Product Change Notice (PCN)

PCN Number: **PCN-0455008R**

Product(s) Affected: *PJ-036BH-SMT-TR*

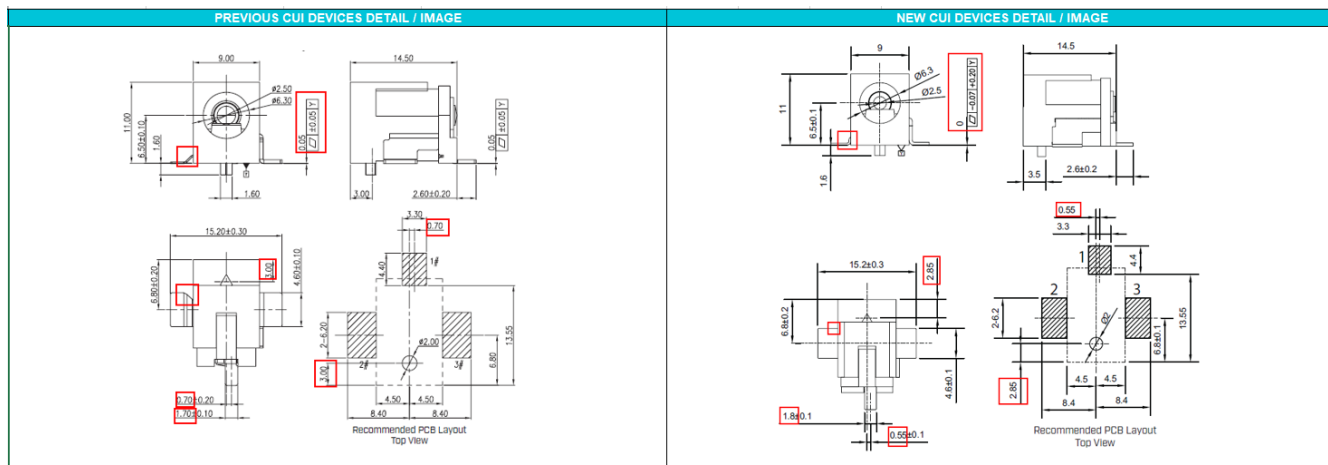
Description of Change: *Product re-engineered for improved manufacturability and production yield. Coplanarity specifications changed. Shape of terminal 2 changed. Location and size of terminal 1 changed. Locating post PCB hole location changed. See image below for reference and check CUI Devices website for updated drawing. Cosmetic differences may be visible and not affect the form fit and function of the product.*
